Technical Bulletin (TB-0015)

Replacement of INT 69/70 and PTC Oil Sensor

August 2010

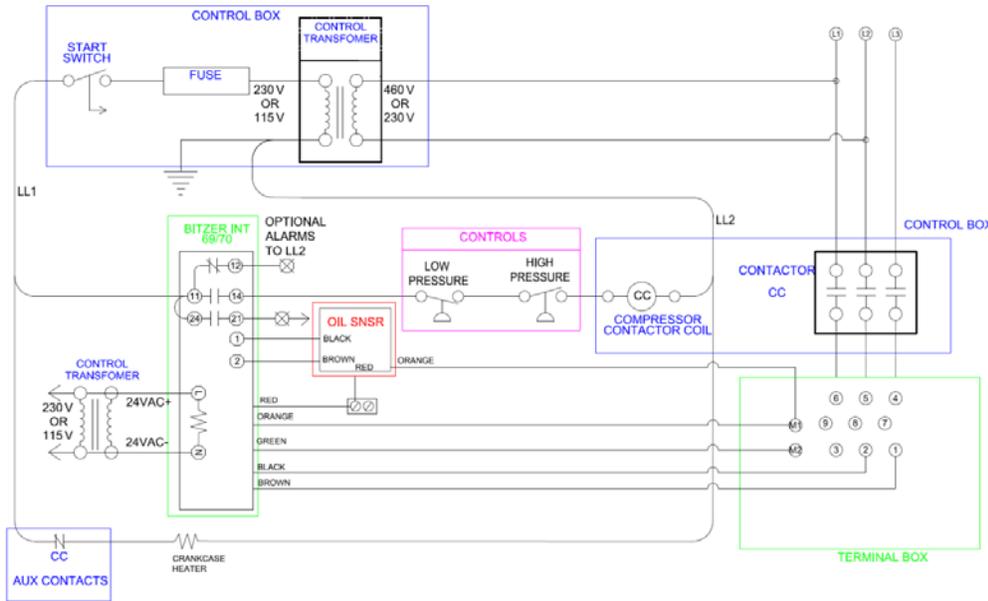
WIRING INSTRUCTIONS (Ref. Section 5 -- Wiring Diagram)

1. Make sure compressor is properly evacuated and all power is shut off to the compressor.
2. Remove the oil sensor and each of the wires (red, black, brown and orange) completely from inside the terminal box.

3. Remove INT 69/70.
 - a. Label wires from the terminals 11, 12, 14, 21, L, and N. as they are removed.
Note: The 24VAC wiring (L, N) may be re-used later if wiring is sufficient for control voltage (120 or 230).

- b. Remove the red, black, brown, orange, and green wires (they will not be used).
4. Remove the wires from 24VAC XFMR (located in terminal box). Label the wires according to their terminals (24VAC+ and 24VAC-) and close off with wire nuts. If the XFMR is not used to power anything else then it can be removed completely.

5. Install the OLC-K1. Verify the threads are correct (M20 w/ metal gasket or NPT tapered pipe threads). Install two pieces separately. Run wire to terminal box.

WIRING DIAGRAMS:

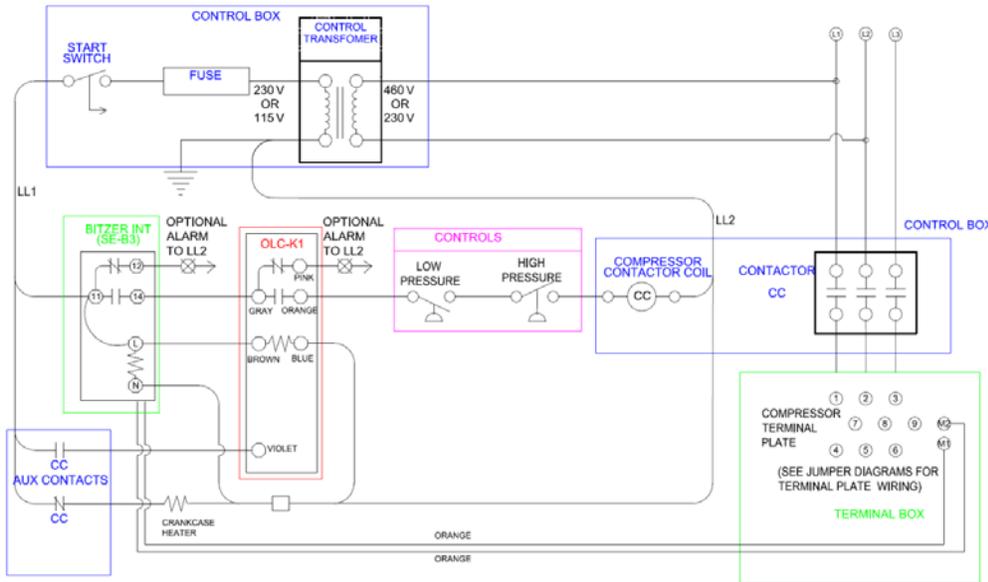
INT 69/70 with PTC Oil Sensor

Using the OLC/K1 and SE-B3

6. Install the SE-B3 in terminal box.
7. Replace wires as follow:
 - a. #11 Wire from INT 69/70 → SE-B3 Terminal #11 (To compressor control LL1)
 - b. #12 Wire from INT 69/70 → SE-B3 Terminal #12 (To *optional* compressor high temp alarm)

- c. #14 Wire from INT 69/70 → Orange wire OLC-K1 (wire nut) (To HPC common)
 - d. #21 Wire from INT 69/70 → Pink wire OLC-K1 (wire nut) (To *optional* oil fail alarm)

- e. Install a jumper from SE-B3 #11 to SE-B3 "L"
 - f. Install Brown wire OLC-K1 into SE-B3 terminal #11
 - g. Install Gray wire OLC-K1 into SE-B3 terminal #14

- h. Install the two orange wires leading out of the SE-B3 into M1 and M2 (use terminal spade connectors provided on the M1 and M2 leads).
 - i. The crankcase heater should have two wires; one from normally closed aux. compressor contactor and the other to the common group (LL2). Take the wire from the common and tie it together with the Blue wire from the OLC-K1. Also include with this wire nut a third wire that leads to the SE-B3 terminal N.

- j. Install a power wire (LL1) to the N.O. on compressor contactor auxiliary (install jumper wire from N.O. compressor contactor aux #1 to "common" on compressor contactor aux. #2).

- k. Install a wire from the other side of the aux contacts to the violet wire OLC-K1.
**Instead of running new wire from the control box to the compressor terminal box, it may be possible to use the 24VAC wires that already exist if the wire gauge is the proper size.

- i. Take L wire from INT69/70 and connect with Violet wire OLC-K1 (wire nut).
 - ii. The N wire from INT69/70 is not used. (close off with wire nut).
 - iii. Install the other end of the L wire (should be labeled 24VAC+) into the other side of the normally open aux contacts.
